Access Compliance Report

Intersection ID: 8228	Main Street: CROSSRIDGE_RD	Cross Street: SULLINS_RD	Location:	N
ADA ID: 28B7CA15FC77	Ramp Type: Perp	Initial Pass/Fail: Fail	Overall Compliance: No	Severity Score: 10
Codes/Mitigation Info/Possible Solution		Field Measurements/Component Compliance

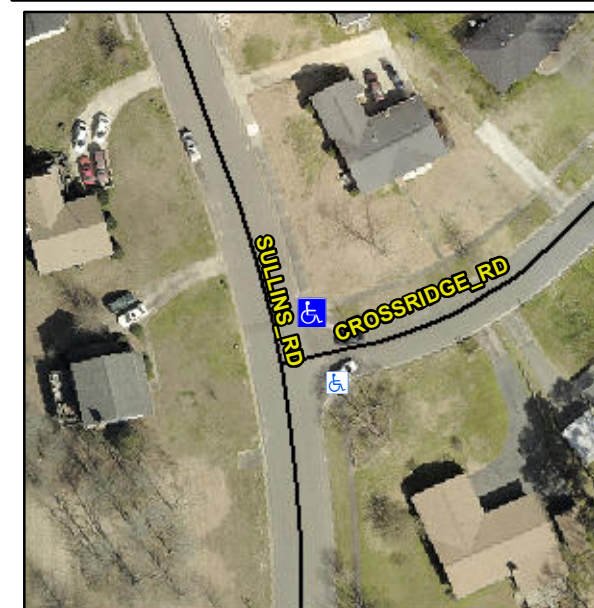
Not Found, R304.5.1, R304.5.3

Compliance	Description	Data	Compliance	Description	Data
N/A	Ramp Length (in)	72.0	Yes	Ramp Slope (%)	5.0
No	Ramp Width (in)	47.5	No	Ramp XSlope (%)	3.2
N/A	Flare Type LT	N/A	N/A	Flare Type RT	N/A
N/A	Flare Slope LT (%)	N/A	N/A	Flare Slope RT (%)	N/A
N/A	Flare Traversable LT?	N/A	N/A	Flare Traversable RT?	N/A
N/A	Landing Length (in)	N/A	N/A	DWS Provided?	N/A
N/A	Landing Width (in)	N/A	N/A	DWS Contrast?	N/A
N/A	Landing Slope (%)	N/A	N/A	DWS Length (in)	N/A
N/A	Landing X Slope (%)	N/A	N/A	DWS Full Width?	N/A
N/A	Landing Curb? (Y/N)	N/A	N/A	DWS Offset (in)	N/A
N/A	Shared Landing?	N/A			
N/A	Gutter Ponding?	N/A	N/A	Gutter Slope (%)	N/A
N/A	Gutter Lip Ht (in)	0.5	N/A	Gutter X Slope (%)	N/A
N/A	Painted X Walk1?	No	N/A	Painted X Walk2?	N/A
	X Walk 1 Direction	To S		X Walk 2 Direction	N/A
N/A	X Walk 1 Width (in)	N/A	N/A	X Walk 2 Width (in)	N/A
	X Walk 1 Slope (%)	0.3		X Walk 2 Slope (%)	N/A
	X Walk 1 X Slope (%)	5.6		X Walk 2 X Slope (%)	N/A

Remove & Replace Entire Ramp.
